Docket Item #6
Development Special Use Permit with Site Plan
#2007-0013
Alexandria Country Day School-2400 Russell Road

Project Name: Alexandria Country Day School	General Data:	
	PC Hearing	November 6, 2008
Location: 2400 & 2500 Russell Road	CC Hearing	November 15, 2008
	If approved, DSUP Expiration:	May 15, 2010 (18 months)
	Campus Size:	3.8 acres
	Zone:	R-12 Single Family
Applicant: Alexandria Country Day School by Duncan Blair, attorney	Gross Floor Area:	Proposed Addition: 14,613 SF Existing Building: 32,245 SF
	Dwelling Units:	N/A
	Small Area Plan:	Northridge / Rosemont
	Historic District:	N/A

Request for a development special use permit, with site plan and density transfer under Section 7-2300 of the Zoning Ordinance, for a 14,613 sq.ft. addition to an existing private elementary school to accommodate a gymnasium, kitchen and cafeteria.

Fig 8: Rear (West) Elevation

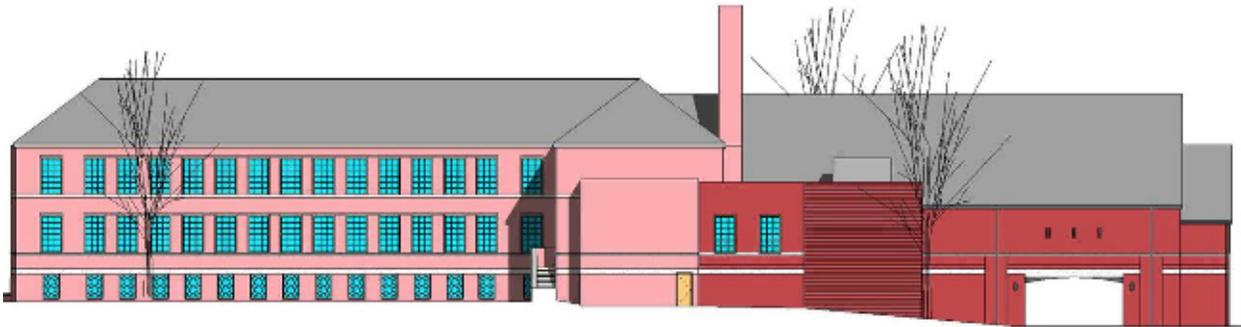
71. The air handling unit proposed on the west roof of the new addition shall be relocated away from adjacent residential area and/or screened and baffled sufficient to meet the noise ordinance in a manner that is visually attractive to the satisfaction of the Directors of Planning and Zoning and Transportation and Environmental Services. (P&Z)
